Re: Project Name: University of Nebraska- Lincoln NHLIA TI
DLR Group Project No.: 10-23123-00
City of Lincoln Record Number: B2302110

University of Nebraska
Nebraska Hospitality Leadership and Innovation Academy
Tenant Improvement
2101 Transformation Drive
Lincoln, NE. 68508

COMBINED CONTRACT
May 06, 2024

NOTICE TO BIDDERS:

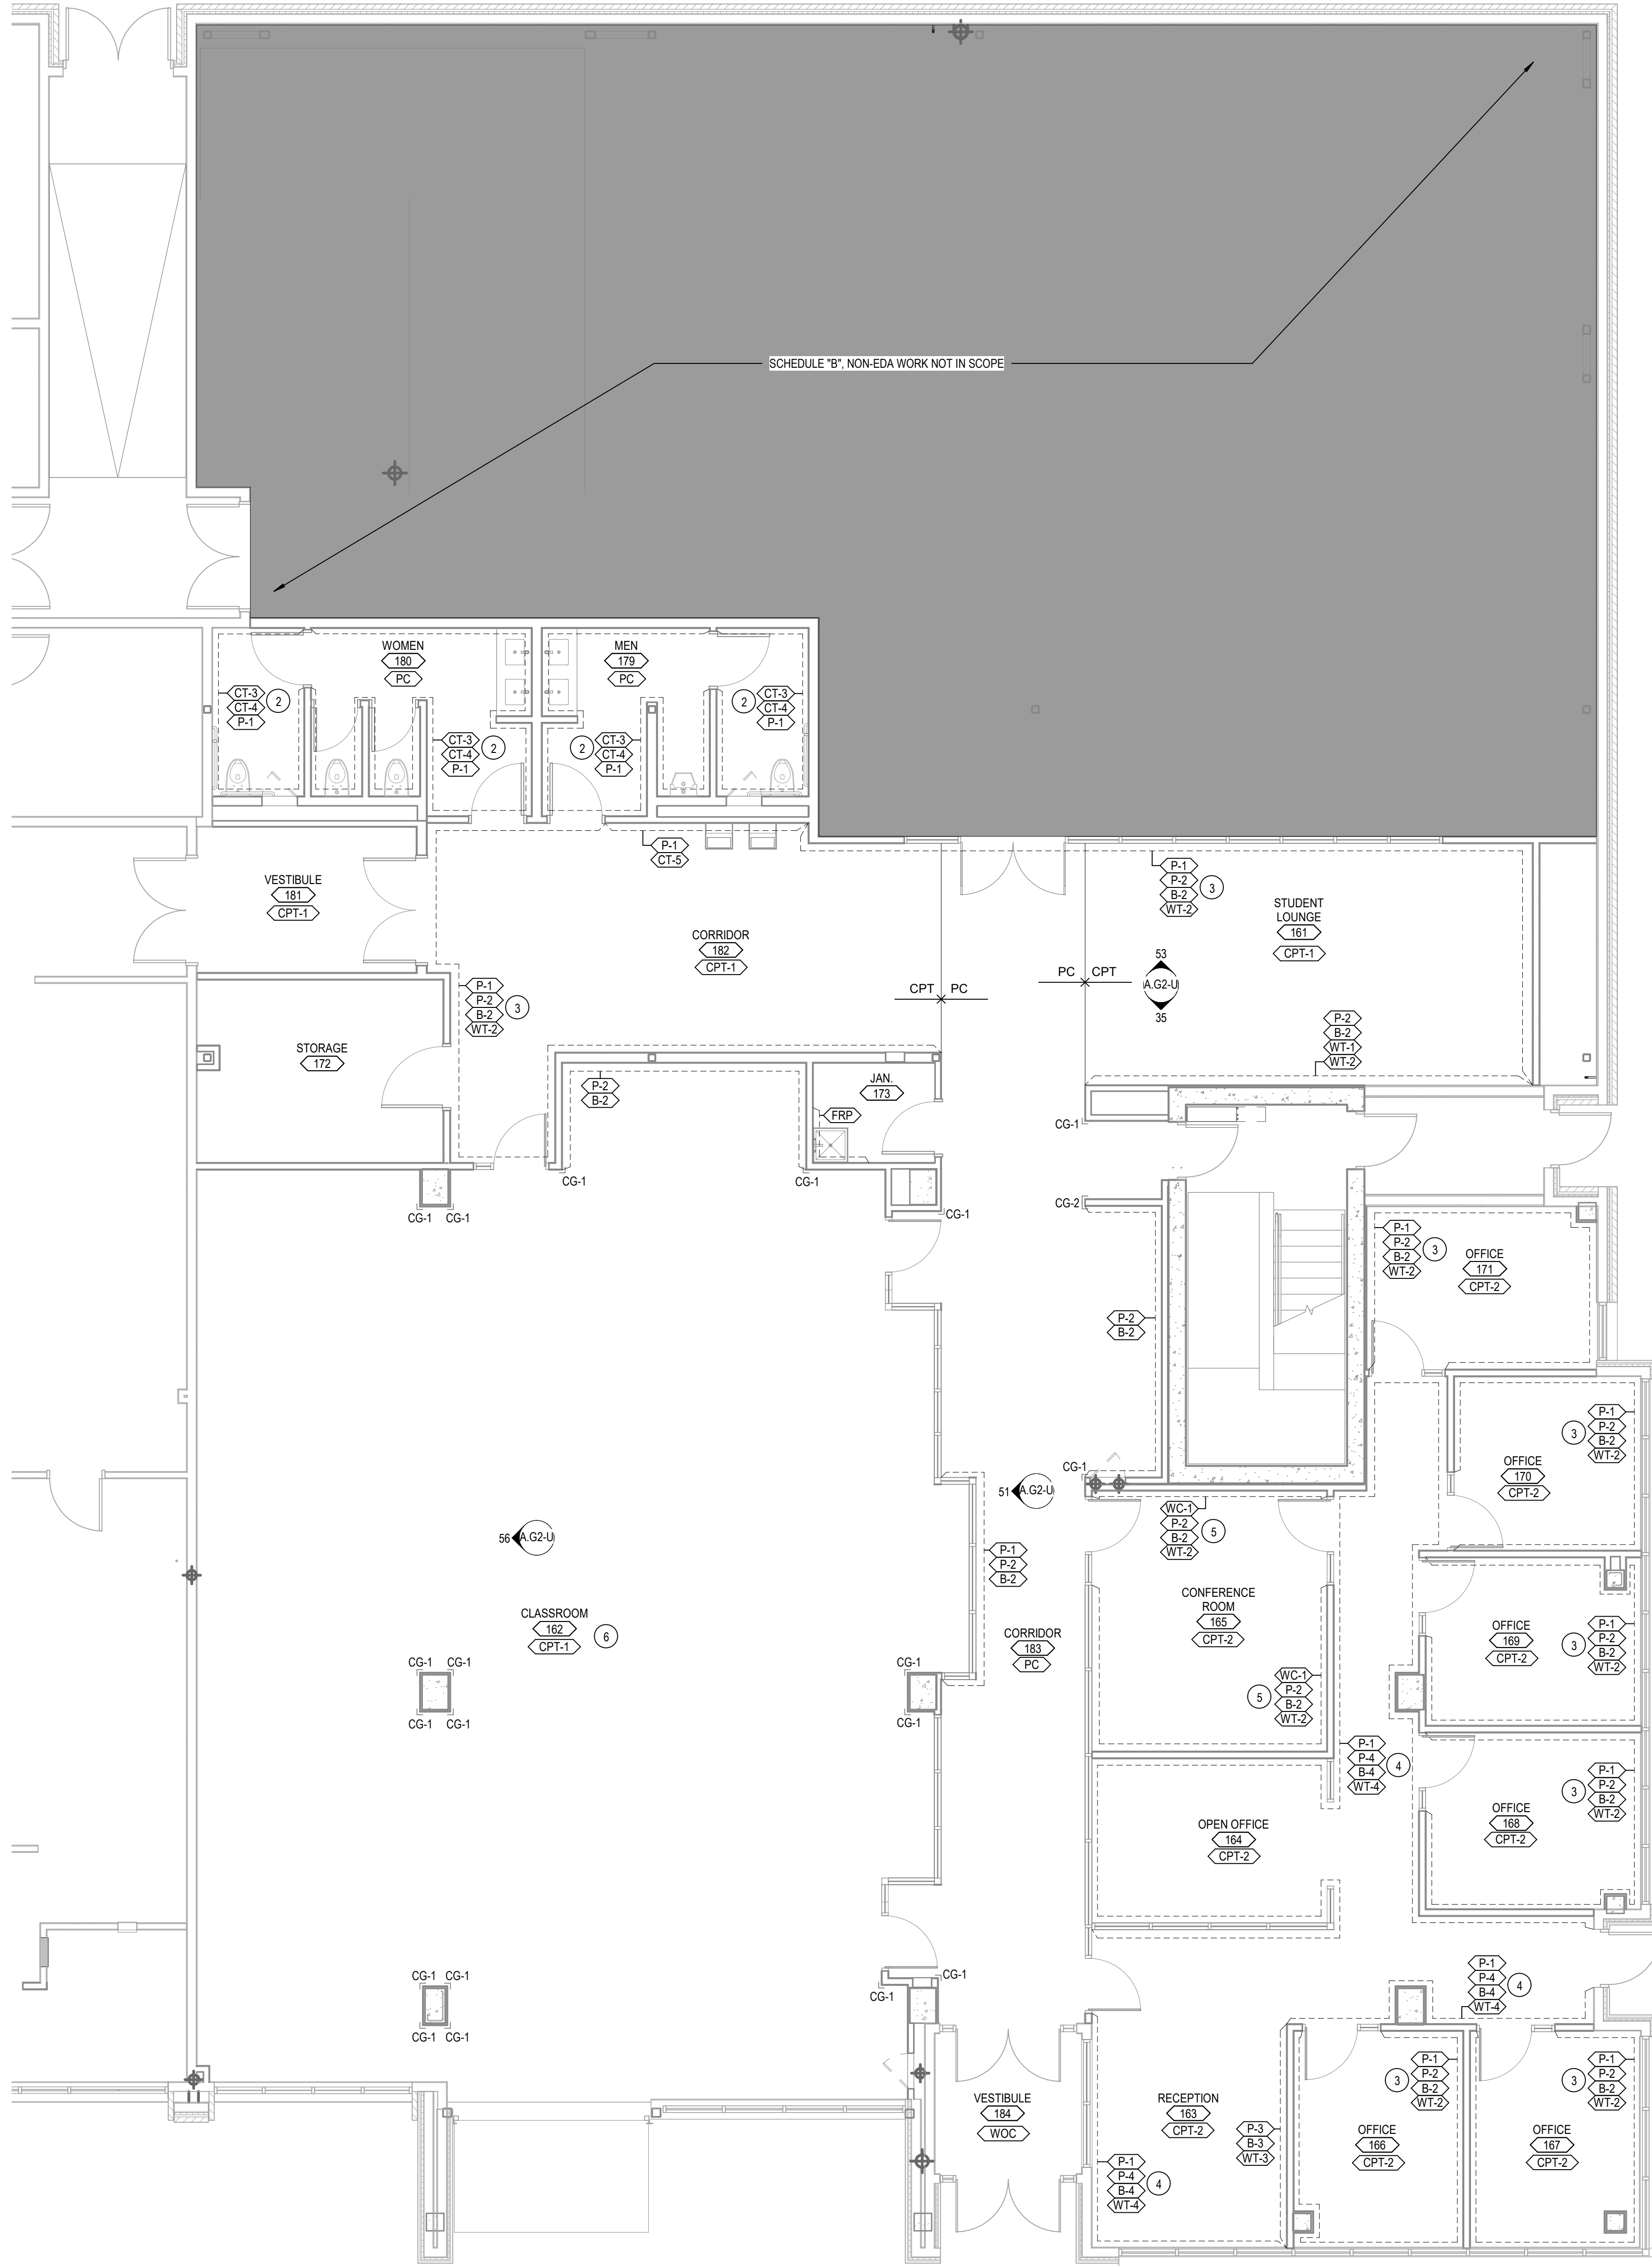
- A. Delete A.A4-U in its entirety and replace with attachment A.A4-U.
 1. FINISH SCHEDULE has been revised to remove teaching kitchen finishes: CT-1, CT-2, CT-5, 095436 - SUSPENDED DECORATIVE GRIDS, and 096723 - RESINOUS FLOORING.
 2. Resinous flooring is not a part of the scope of work.

UNIVERSITY POWER PLAN - PHASE 1
SCALE: 3/16" = 1'-0"

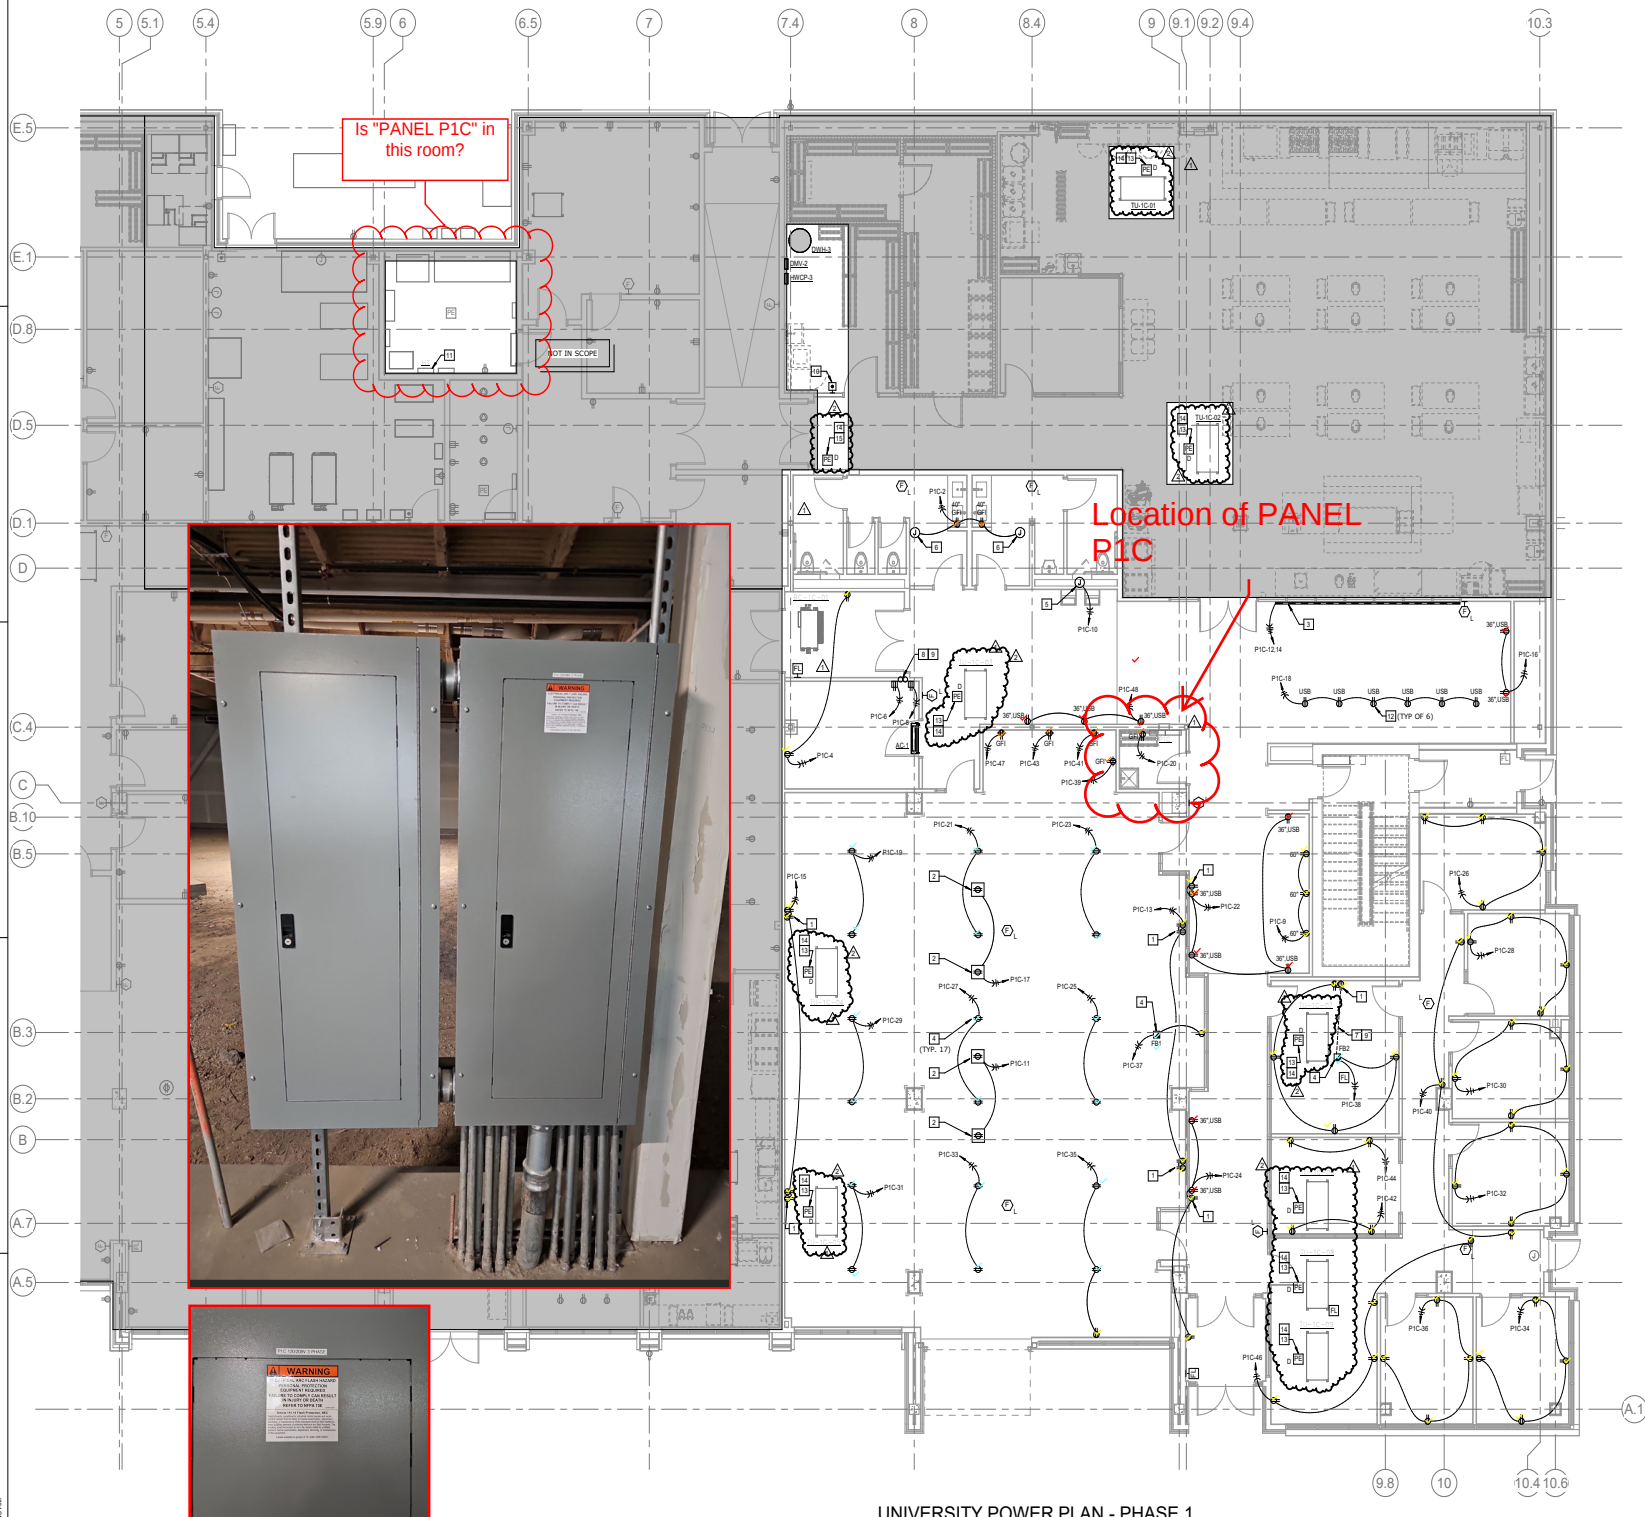
- A.** For your reference, see drawing and images in attachment #5 for location of panel P1C.
